CITY PLANNING COMMISSION

RE: Neumann-Smith Architecture to amend Article XVII, District Map 4, of the 1984 Detroit

DATE: May 9, 2019

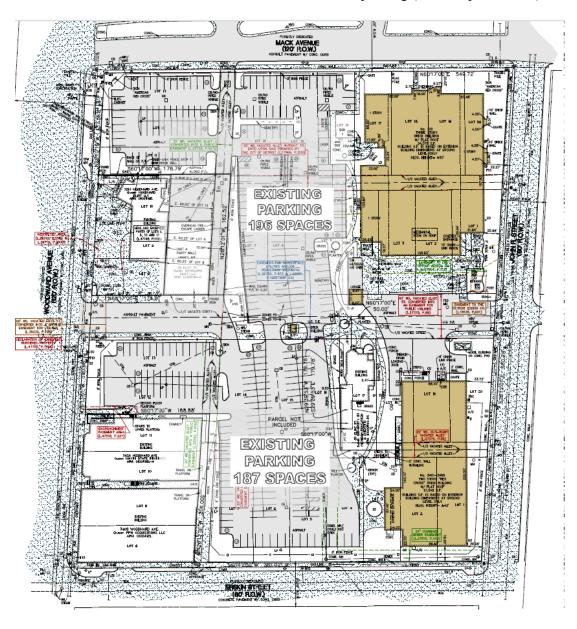
There are currently an approximate 383 surface level off-street parking spaces on the Red Cross site. If built the SOMA parking deck would replace the portion of the site that houses 187 of those spaces and replacing it with the proposed deck which is to hold 591 spaces. There is a case to be made that this would be a more efficient use of the current surface parking (See site plan below).

Proposed open space on SOMA site

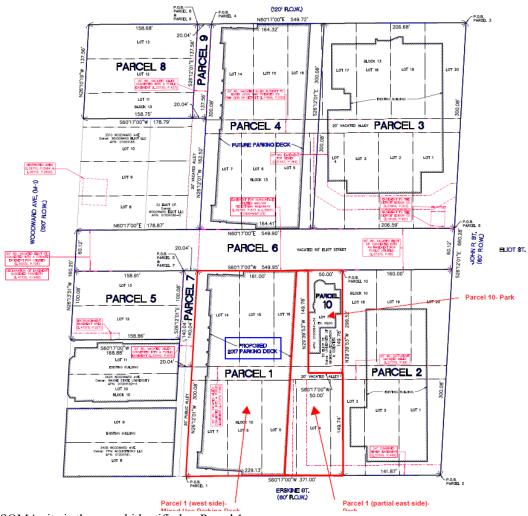
One of the best features of this proposal is that it will create a park/open space amenity adjacent to the structure. The park would complement the commercial and retail space that it is to rest alongside. This will serve to create even more synergy for the businesses as well as bring alive a site that has been dormant for decades serving only as surface parking. This will be a major amenity for the community as the developer plans for it to remain a public space. This help to address the lack of open spaces in the Brush Park neighborhood and supplement City efforts that are also underway.
